Access Compliance Report

Public Rights-of-Way

(Pedestrian Signals)

Intersection ID: N/A	Main Street:	Cross Street: N/A	Location: N/A
ADA ID: AC74D7F9C13F	Signal Type: One Push Button-Non APS	Overall Compliance: No	Severity Score: BTN 1: N/A BTN 2: N/A No BTN: N/A
Codes/Mitigation Info/Possible Solution		Field Measurements/Component Compliance

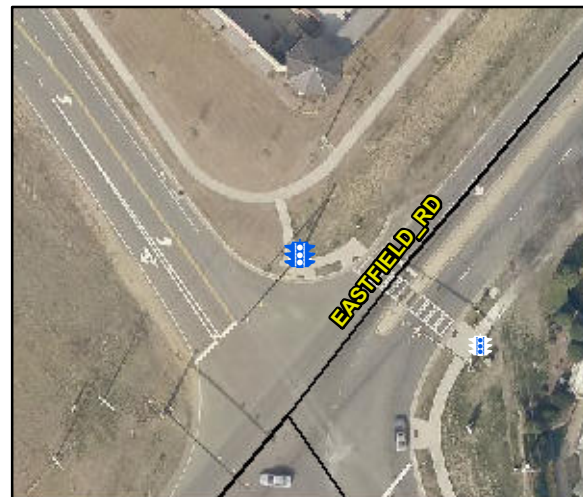
Surveyor Notes: NO SOUND FROM BUTTON

Compliance	Description	Data	Compliance	Description	Data
	Button Count	Button1	N/A	Distant to Additional Button (in)	N/A
	Additional Button Present?	No		Additional Button ID	N/A
N/A	Signal Buttons Required?	N/A	N/A	Additional Ped Posts Required	N/A
	How Many Ped Street Xings?	N/A		Located In An Island/Median?	N/A
N/A	B 1 Sign Present?	Yes	N/A	B 2 Sign Present?	N/A
Yes	B 1 Sign Purpose?	Yes	N/A	B 2 Sign Purpose?	N/A
Yes	B 1 Sign Lettering & Contrast?	Yes	N/A	B 2 Sign Lettering & Contrast?	N/A
Yes	B 1 Parallel To XWalk?	Yes	N/A	B 2 Parallel To XWalk?	N/A
Yes	B 1 PAR to Button?	No	N/A	B 2 PAR to Button?	N/A
No	B 1 PAR to XWalk?	Yes	N/A	B 2 PAR to XWalk?	N/A
No	B 1 Clear Floor Space?	No	N/A	B 2 Clear Floor Space?	N/A
No	B 1 FWD Approach?	No	N/A	B 2 FWD Approach?	N/A
N/A	B 1 FWD Approach Constrained?	N/A	N/A	B 2 FWD Approach Constrained?	N/A
N/A	B 1 FWD Approach Reach (in)	48.0	N/A	B 2 FWD Approach Reach (in)	N/A

N/A	B 1 FWD Approach Width (in)	N/A	N/A	B 2 FWD Approach Width (in)	N/A
N/A	B 1 FWD Approach Obstruction?	Yes	N/A	B 2 FWD Approach Obstruction?	N/A
N/A	B 1 FWD Approach Obstruction Dist (in)	2.0	N/A	B 2 FWD Approach ObstructionDist (in)	N/A
No	B 1 PARA Approach?	No	N/A	B 2 PARA Approach?	N/A
N/A	B 1 PARA Approach Constrained?	N/A	N/A	B 2 PARA Approach Constrained?	N/A
N/A	B 1 PARA Approach Reach (in)	48.0	N/A	B 2 PARA Approach Reach (in)	N/A
N/A	B 1 PARA Approach Width (in)	N/A	N/A	B 2 PARA Approach Width (in)	N/A
N/A	B 1 PARA Approach Obstruction?	Yes	N/A	B 2 PARA Approach Obstruction?	N/A
N/A	B 1 PARA Approach Obstruction Dist (in)	2.0	N/A	B 2 PARA Approach ObstructionDist (in)	N/A
N/A	B 1 Clear Floor Space Slope (%)	2.1	N/A	B 2 Clear Floor Space Slope (%)	N/A
N/A	B 1 Clear Floor Space XSlope (%)	0.5	N/A	B 2 Clear Floor Space XSlope (%)	N/A
N/A	B 1 PAR Slope (%)	N/A	N/A	B 2 PAR Slope (%)	N/A
No	B 1 Height (in)	49.5	N/A	B 2 Height (in)	N/A

N/A	B 1 Clear Xing Direction?	Yes	N/A	B 2 Clear Xing Direction?	N/A
	B 1 Crossing Direction	To SE		B 2 Crossing Direction	N/A
No	B 1 DistanceTo XWalk (in)	300.0	N/A	B 2 DistanceTo XWalk (in)	N/A
No	B 1 DistanceTo Curb (in)	289.0	N/A	B 2 DistanceTo Curb (in)	N/A
Yes	B 1 Diameter (in)	2.0	N/A	B 2 Diameter (in)	N/A

Possible Solutions: Replace Signal Push Button With APS Button on New Post. Remove & Relocate Sign.
